# MIAMI BEACH

Historic Preservation Board

SUBJECT: HPB24-0632, **1730 Jefferson Avenue.**

The applicant has submitted plans entitled "Hill & Gamboa Family Residence", as prepared by DGO Architecture, dated June 17, 2025.

*Currently proposed rendering*

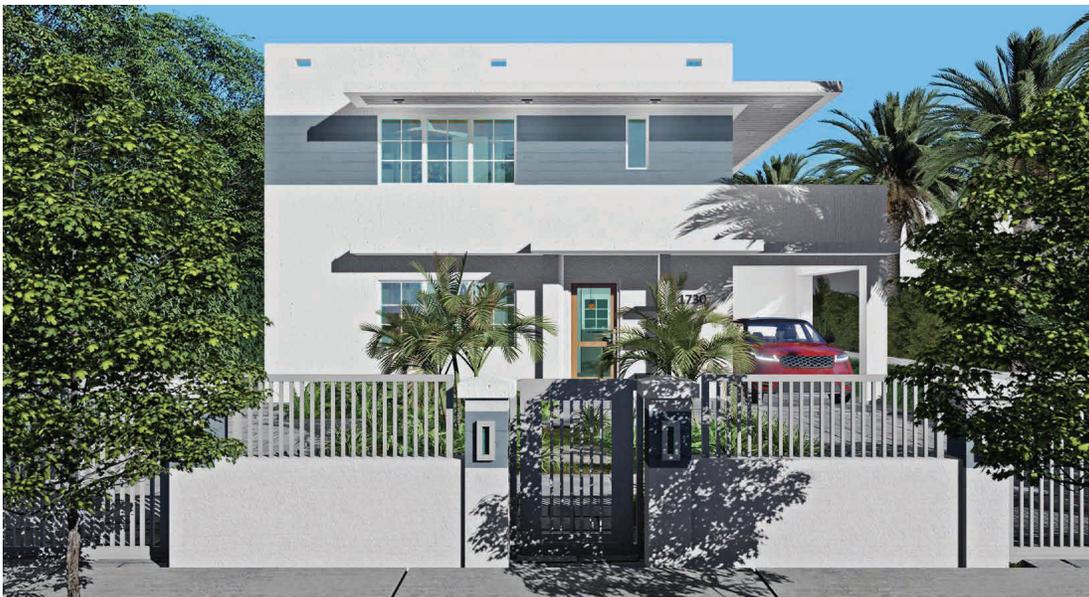
On April 22, 2025, the Historic Preservation Board reviewed and continued the subject application to a date certain of June 17, 2025. Since the April hearing, the applicant has submitted revised plans including the following modifications:

- The front façade of the home has been further refined including:
  - The retention of the racing stripes at the second level.
  - The introduction of historically accurate window muntins.
  - The proposed eyebrow/overhangs have been lowered closer to the top of the existing openings.

- The trim color has been lightened.
- The design of the front wall has been revised to include vertical pickets.
- The rear accessory building rooftop addition has been revised to comply with the required 15'-0" rear accessory building setback resulting in a reduction of the unit size variance request and the elimination of the rear accessory building setback, rear yard open space and rear yard lot coverage variances.

Staff remains supportive of the proposed additions which will not be visible from Jefferson Avenue. Further, staff believes that the modifications to the front façade of the home, as outlined above, are more consistent with the original design. Staff continues to be concerned, however, with the proposed new overhangs which are disconnected from the window and door openings and are not consistent with the original design. As such, staff recommends that the primary façade be retained and restored consistent with available historic documentation, inclusive of the retention and restoration of the existing eyebrows, or their reconstruction.

1. Revised elevation, site plan and floor plan drawings shall be submitted, and at a minimum, such drawings shall incorporate the following:
    - a. The primary (east) façade of the home shall be restored to the greatest extent possible, consistent with available historical documentation, in a manner to be reviewed and approved by staff consistent with the Certificate of Appropriateness Criteria and/or the directions from the Board.
